State of New Mexico
 Energy, Minerals and Natural Resources

SUNDRY NOTICES AND REPORTS ON WELLS
 (DO NOT USE THIS FORM FOR PROPOSALS TO DRILL OR TO DEEPEN OR PLUG BACK TO A DIFFERENT RESERVOIR. USE "APPLICATION FOR PERMIT" (FORM C-101) FOR SUCH PROPOSALS.)

Skelly D #5

API 30-025-33297

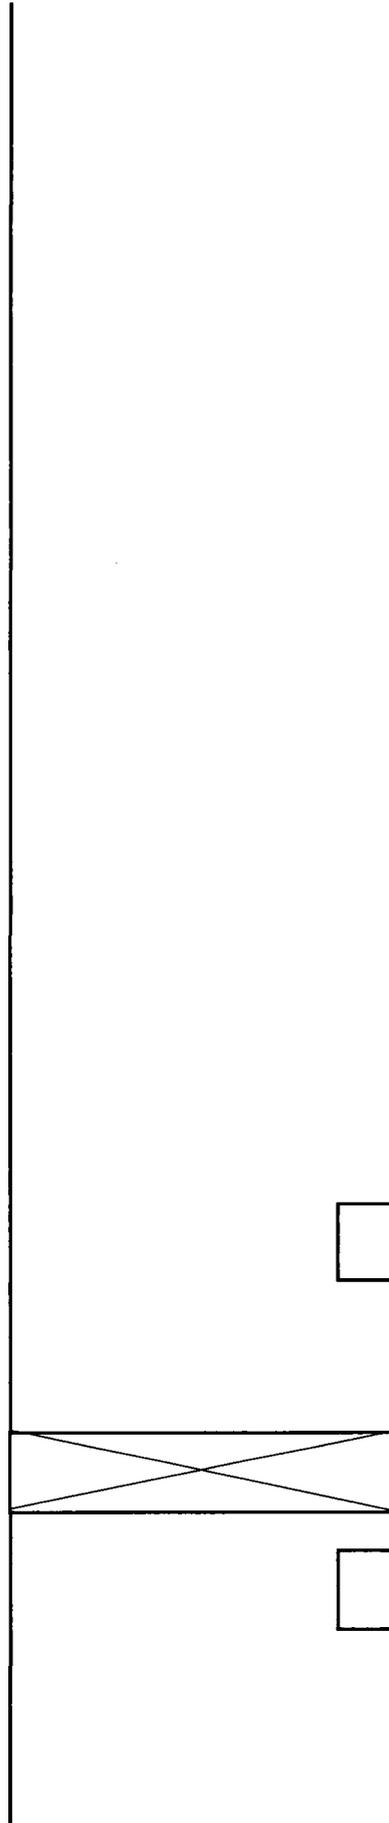
1. Set CIBP @ 3700' w/ 25' cement on top. Circulate well w/ MLF. **WOC TAG (DW Tool)**
2. Spot a 25 sx plug 2600'-2400'. **Pressure test csg to 500#**
3. Spot a 25 sx plug 1250'-1050'.
4. Spot a 50 sx plug 300'-surface.

*TAG CIBP @ 5097
 Spot 25 sx Class
 'C' cement Spot,
 MLF up to 3800'*
